02.00 VARIOUS ITEMS - PROPOSED AMENDMENTS
02.15 SOUTH ELEVATION

Planning Application 2020/1310/P

02.20 EAGLE SOUTH ELEVATION

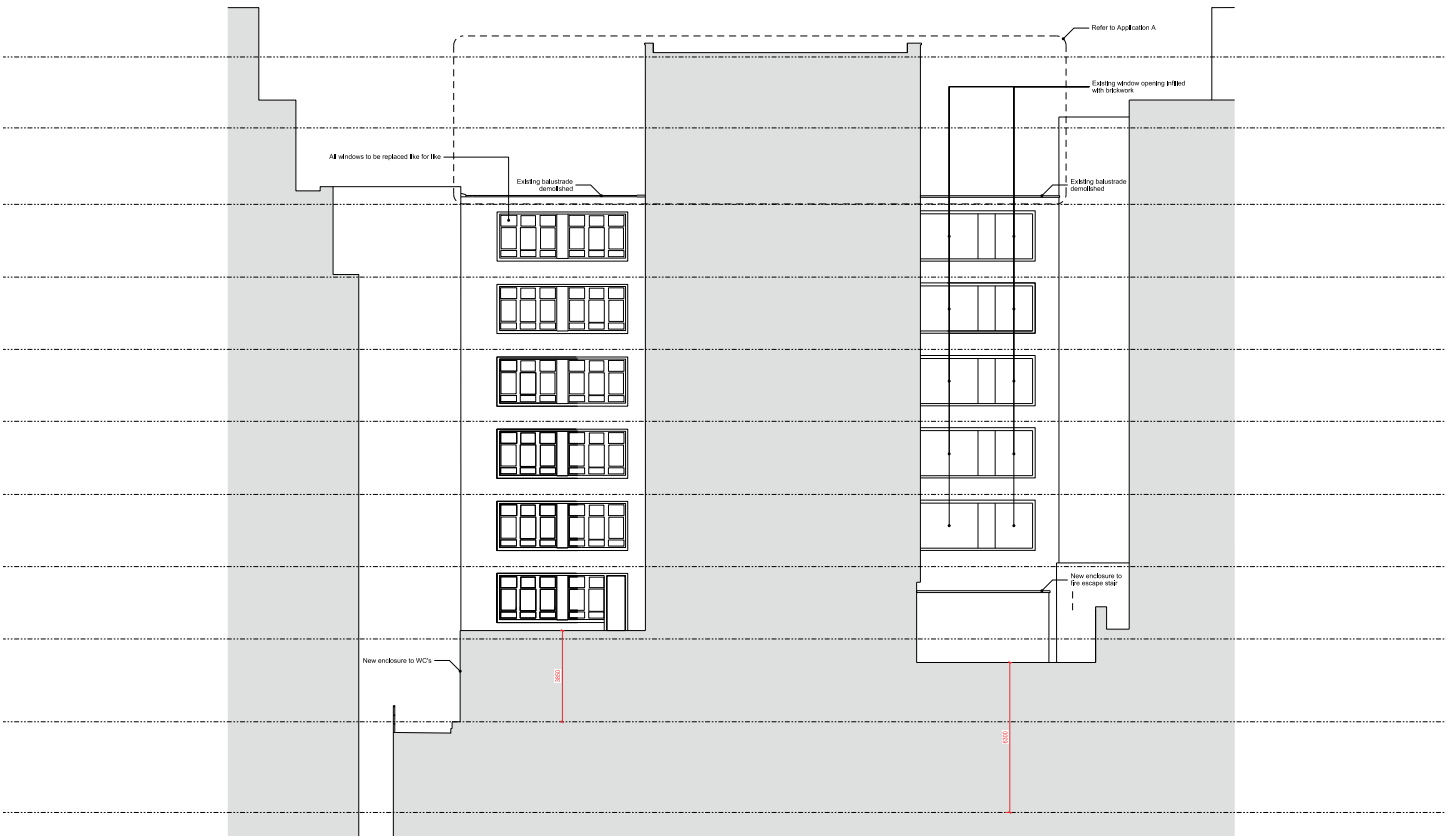
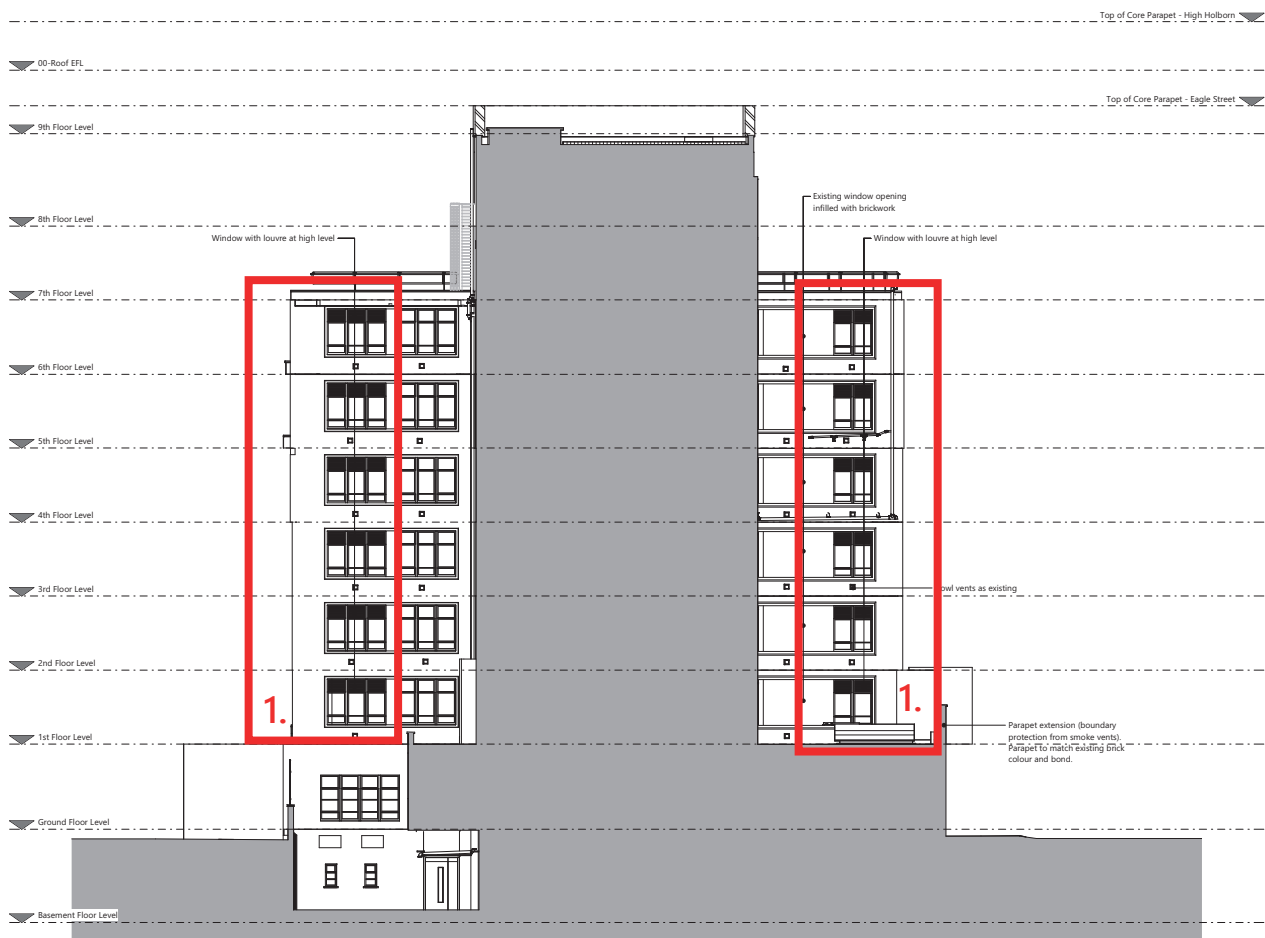
1. Infills minimized on the Eagle street rear facade. Existing windows to be replaced and louvres at high level added.

02.21 TOILET WINDOW BAY

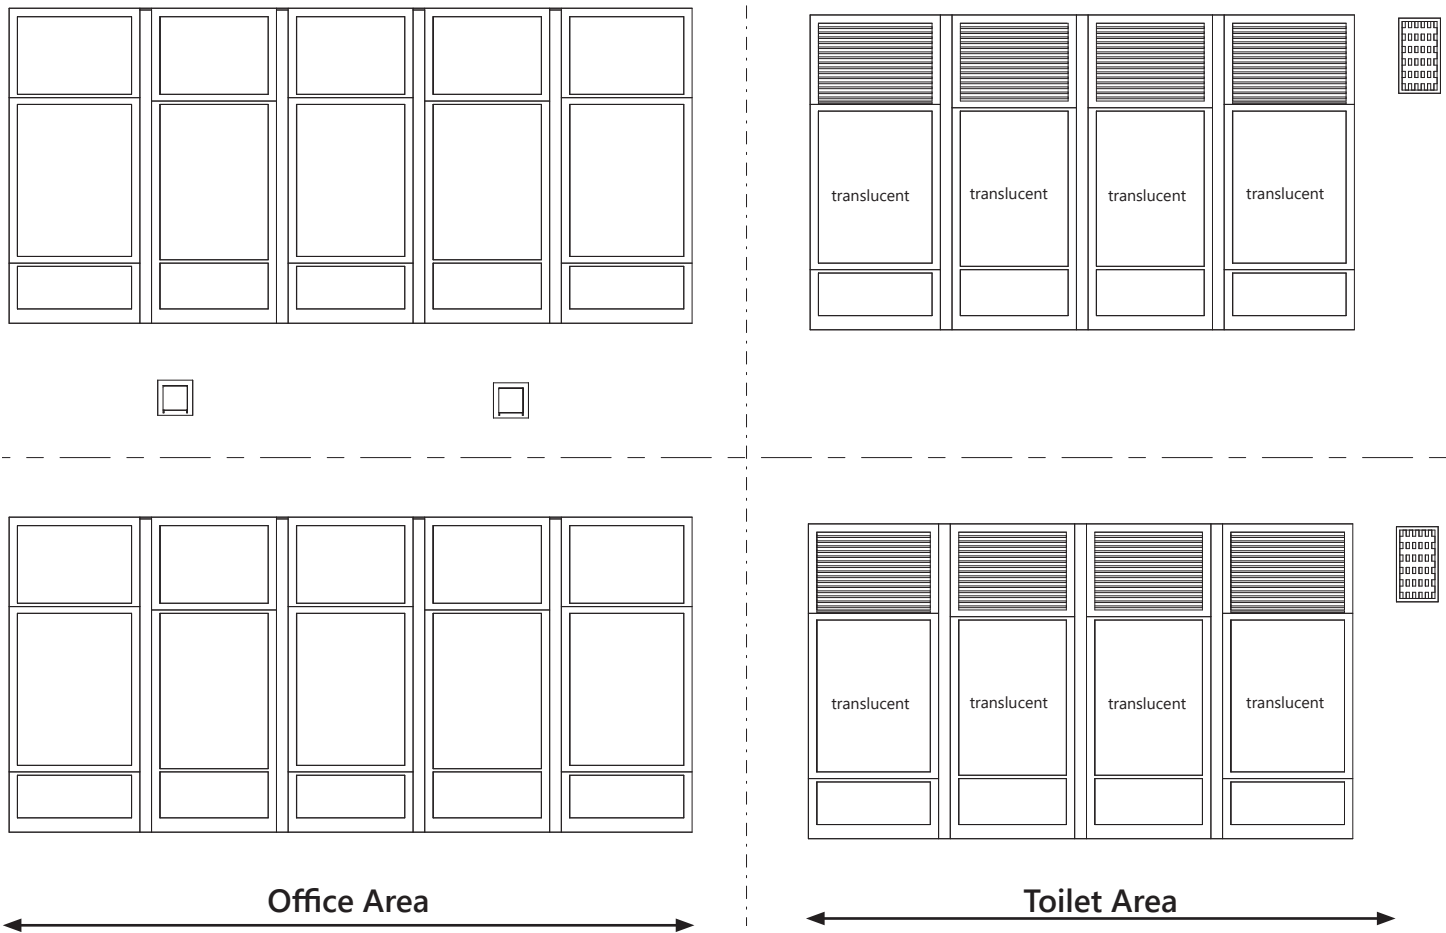
- Window infills omitted.
- Bays to incorporate loured panles at high level.
